Reference: **TB 0192 (08/2025)**

Technical Bulletin

Installation: 5800i AW E (wall hung unit) clearances

REDUCTION TO CLEARANCES OF THE INDOOR UNIT 5800i AW E

Fig 2. New clearances*

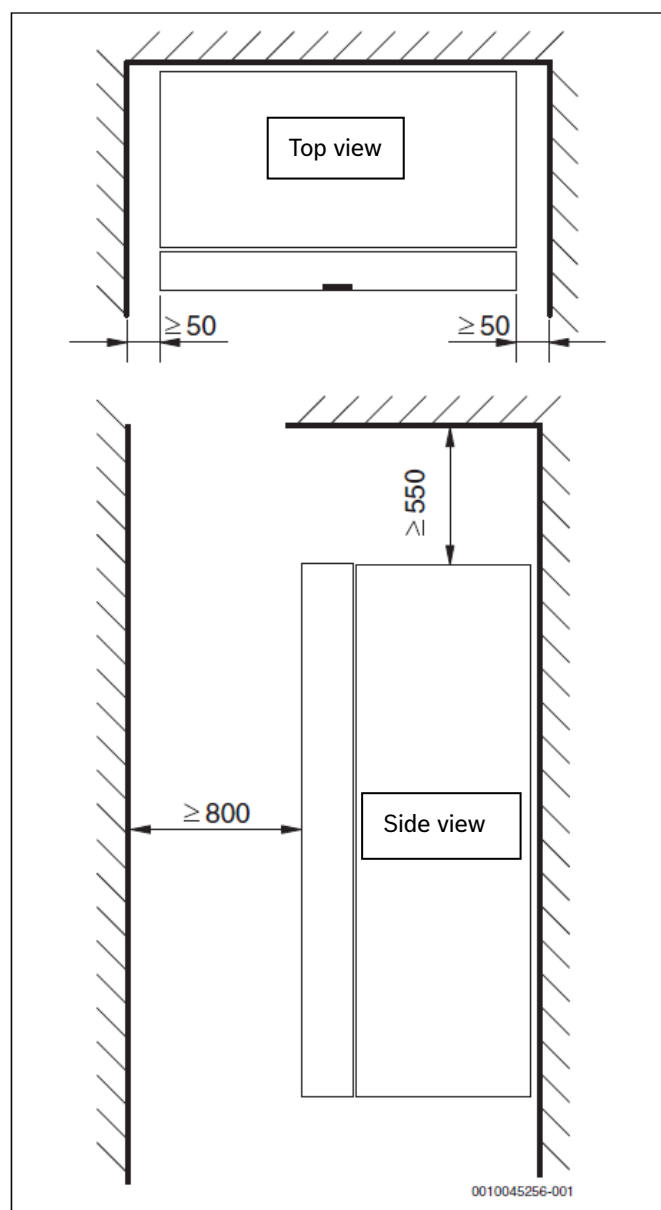
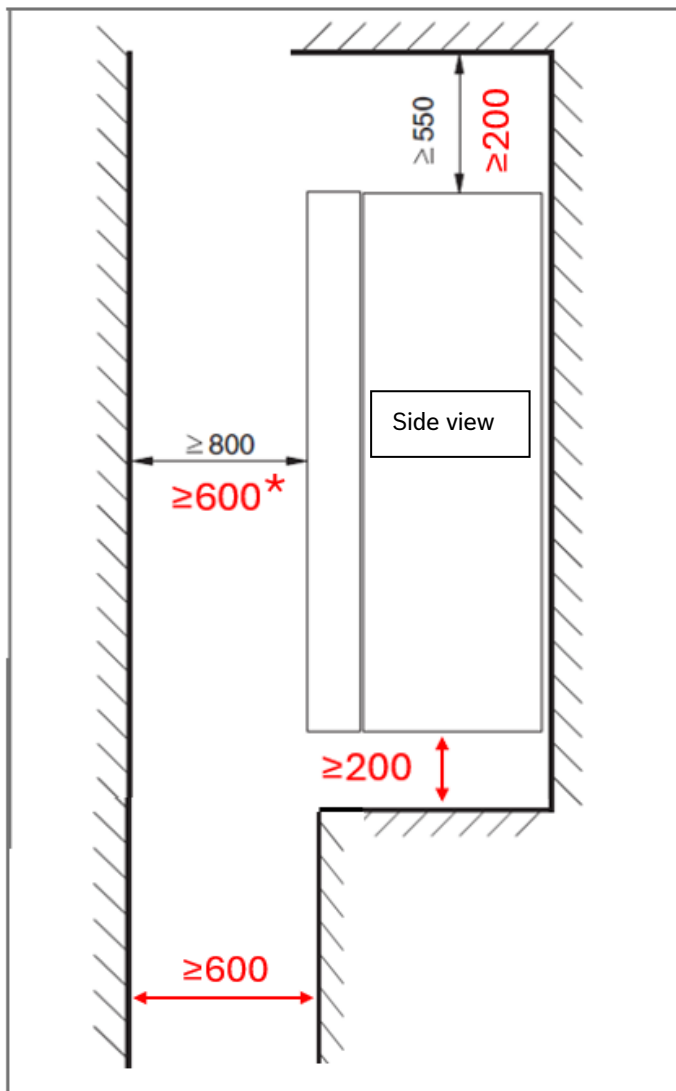
There has been a reduction in clearances for the 5800i heatpump wall hung indoor unit. Please see below in Fig1 the current installation manual clearances followed by the new allowable clearances in Fig 2 and Fig 3. Be aware when reducing certain clearances there may be additional information to abide by.

- The bottom of the appliance case must be between 1000mm and 1500mm from the floor.
- There must be at least 50mm clear space to either the left hand or right hand side of the appliance. (Fig 1.)
- There must be at least 200mm clear space to any object which is sited below the appliance. (Fig 2.)
- There must be 200mm clearance above the appliance. (Fig 2.)
- There must be at least 600mm* clearance in front of the appliance to floor level. Anything which is sited below the appliance must not protrude into this clear space. (Fig 2.)
- 300mm required on left hand side should the front access be reduced from 800mm and no less than 600mm (Fig 3.)

Fig 3. New clearances*

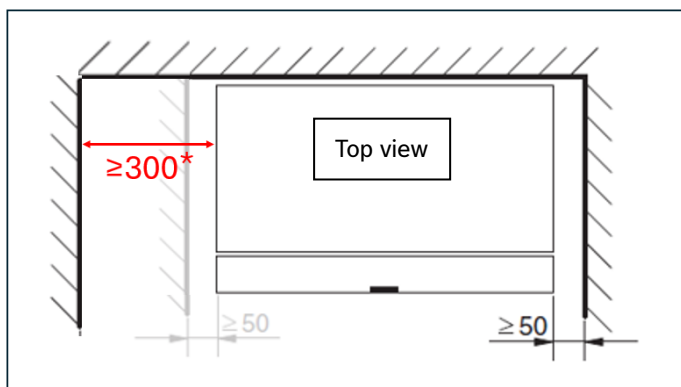
* if the front clearance has been reduced from 800mm to 600mm, then at least 300mm clearance is required on left hand side.
